SUPPLEMENTAL RESPONSES TO CEC STAFF DATA REQUEST SET 2

AVAIO Pittsburg Backup Generating Facility (24-SPPE-01)

ATTACHMENT SUPPLEMENTAL DR LU-2
Revised Vested Tentative Subdivision Map

VESTING TENTATIVE SUBDIVISION MAP
PITTSBURG TECHNOLOGY CENTER
TRACT NO. 9700

SHEET NUMBER
TM3.0

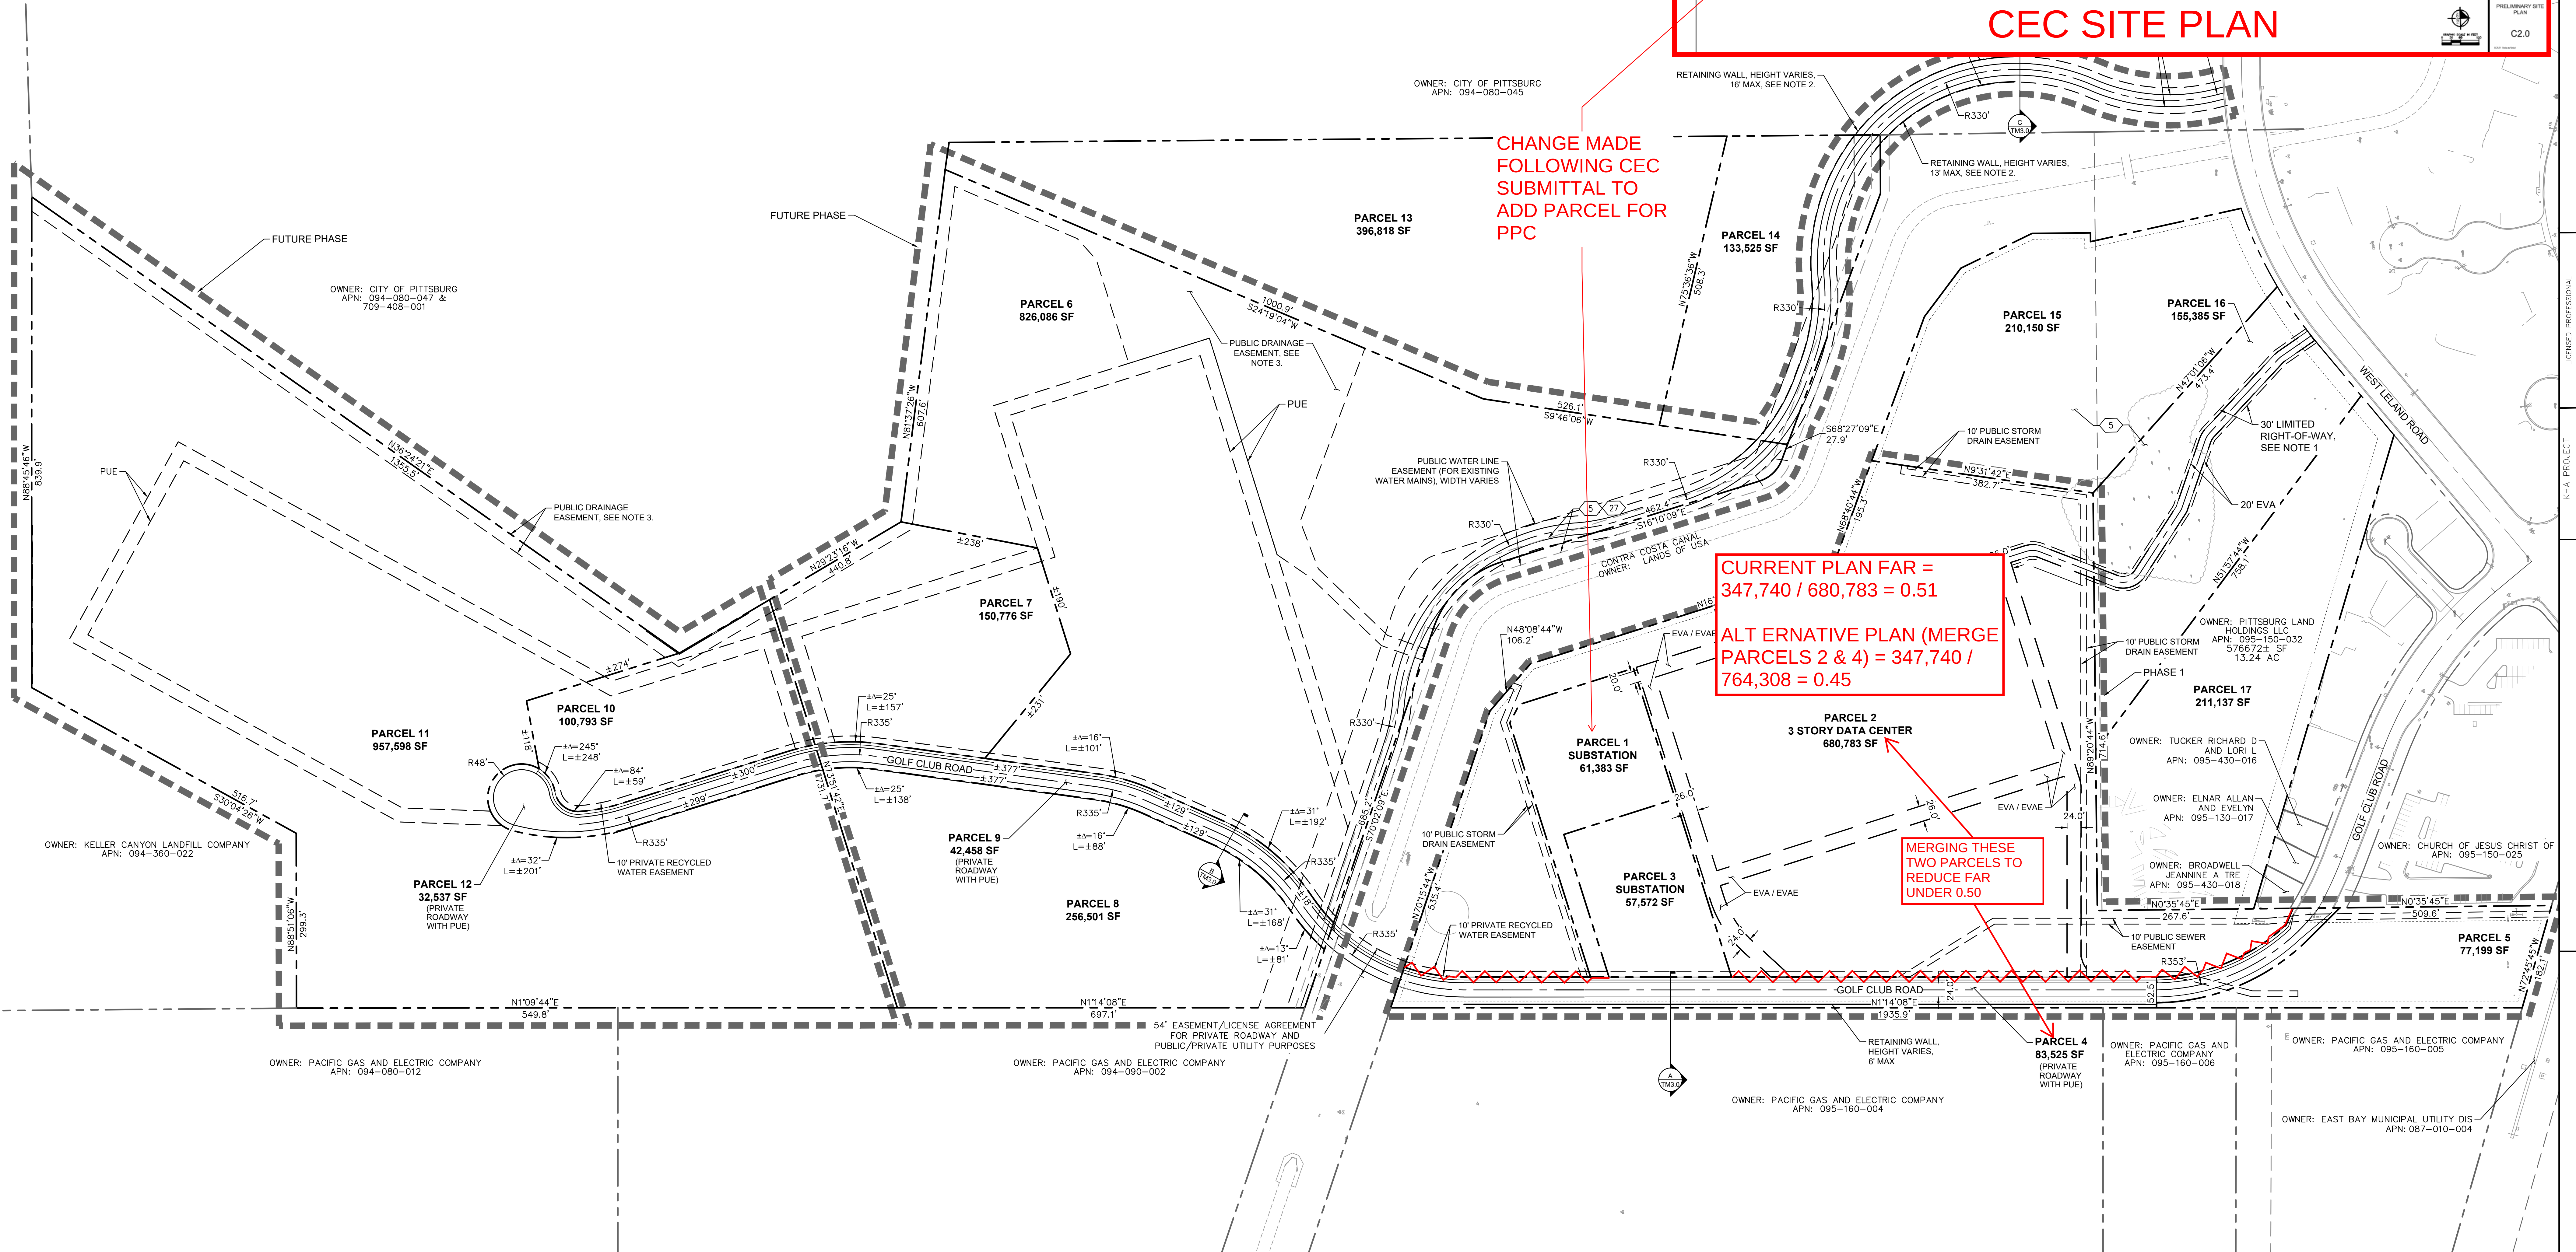
CHANGE MADE FOLLOWING CEC SUBMITTAL TO ADD PARCEL FOR PPC

CURRENT PLAN FAR = 347,740 / 680,783 = 0.51
ALT ERNATIVE PLAN (MERGE PARCELS 2 & 4) = 347,740 / 764,308 = 0.45

MERGING THESE TWO PARCELS TO REDUCE FAR UNDER 0.50

NOTE - ASSUME THAT CEC REVIEWED TM AND SAW ADDITIONAL PARCEL. ADDITIONAL PARCEL REDUCED FAR BELOW 0.50 WHICH IS MAX ALLOWED. MARKUP TO DOCUMENT CHANGE TO BE MADE FOR FINAL MAP TO REDUCE FAR.

In the response to DR LU-2, AVAIO provided Attachment DR-1 which included a Vested Tentative Subdivision Map which included notes in red font that described the parcel merger that would explain the FAR provided. There was a mistake in that description (the term Parcel 1 was mistakenly used instead of Parcel 2). That error has been corrected and the Vested Tentative Subdivision Map with the corrected notations is included in Attachment DR LU-2. When making reference to the Vested Tentative Subdivision Map and any discussion of FAR, please refer to this response and Attachment DR LU-2.
